MAG 208 Water Quality Management Plan  
Small Plant Review and Approval  
for

# The Preserve at Goldfield Ranch Water Reclamation Facility

May 22, 2008

## **1.3.2. Service Area**

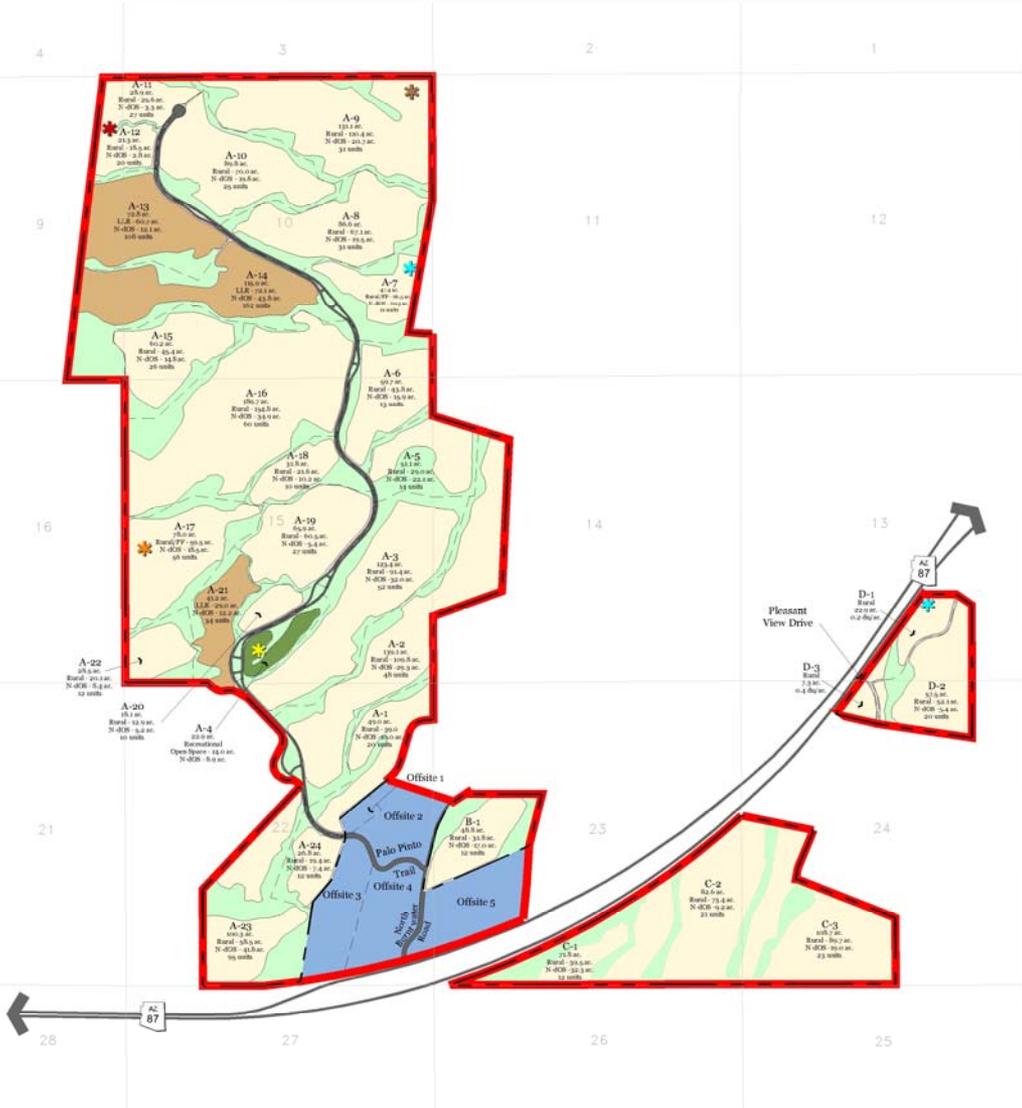
**Issue:** The SRP-MIC Report suggests the 208 Amendment Service Area may be eligible for expansion to serve the regional wastewater treatment needs of additional development within the entire area.

- The Service Area of the 208 Amendment will be expanded to include Parcels C and D.
- There is sufficient property both within and surrounding the plant site to accommodate an expansion.
